Dear Dennis,

Here are the answers,

**1.1 FTAP 835 MHz, EUT Position: Side**

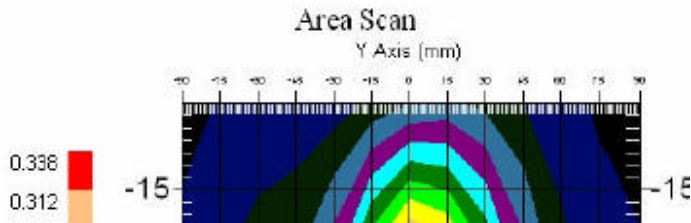
5. Please clearly identify the outline of the EUT in the SAR data plots.

ANS: We have indicated the EUT position in the report.

Please refer the EUT position in appendix D of SAR report,

also you can find the position on page 22 of SAR report <06LR033SAR-F>

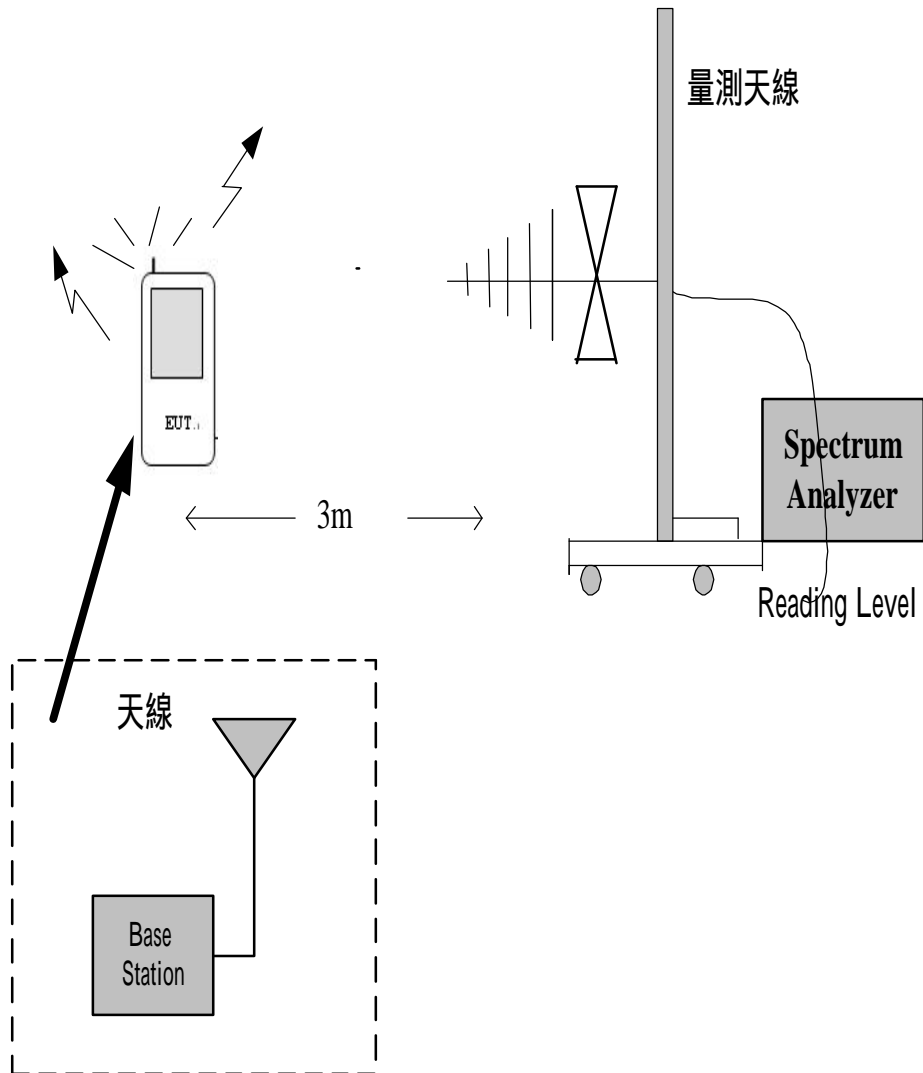
7. Please note that the table of results on page 8 of the report states that the conducted power is ERP. Please note that conducted power is not ERP as ERP is an effective RADIATED power. Please correct the report to properly describe and properly use the correct power units of dBm and not ERP.

8. Please explain and properly identify the term “Path Loss” on page 8 of the report in the conducted power table (section 4.1.4)

ANS: Corrected.

Please refer the updated page 8

ANS: It's what we so called “cable Loss”. I have changed the wording from “Path Loss” to “cable loss”

Please refer the updated page 8
